##### 164<sup>th</sup> session

**1958 Agreement – Consideration of draft amendments  
to existing Regulations submitted by GRE**

### **Proposal for Supplement 9 to the 01 series of amendments to Regulation No. 70 (Rear marking plates for heavy and long vehicles)**

#### **Submitted by the Working Party on Lighting and Light-Signalling\***

Figure 3a

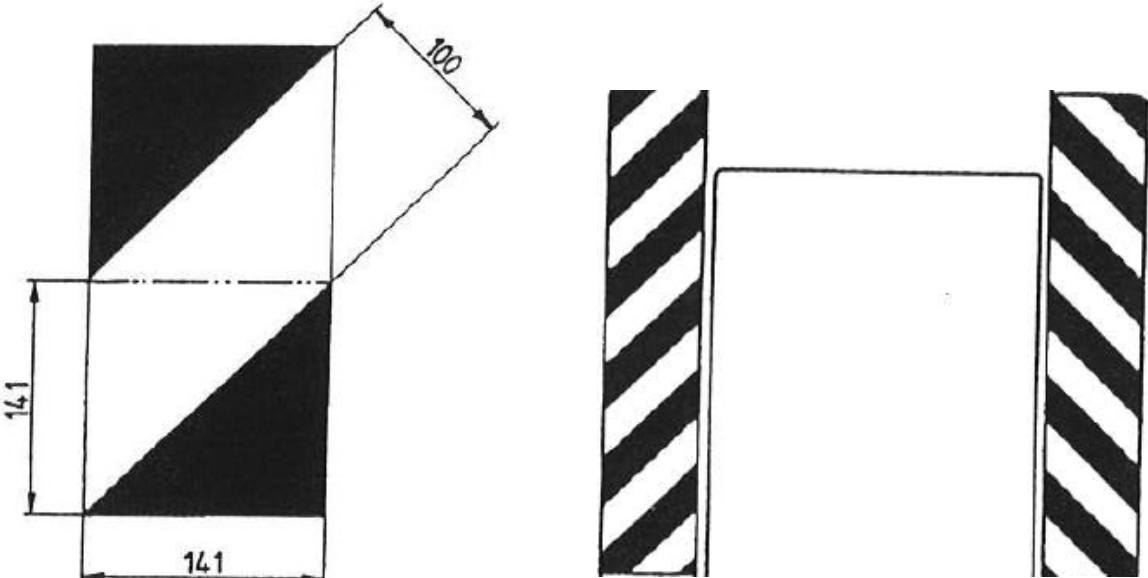
Annex 12, after figure 2, insert a new title and new figures 3a and 3b to read:

"Rear marking plates (Class 5)

"3.4. ...  
Class 5 retro-reflective materials shall consist of red and white diagonal stripes each 100 mm wide sloping outwards and downwards at 45°. The basic standard area is a square of 141 mm in length subdivided diagonally into a white half and red half, which represents one standard area.  
Prescribed shapes, patterns and dimensional features of Class 5 devices are illustrated in figure 3 of Annex 12 to this Regulation."
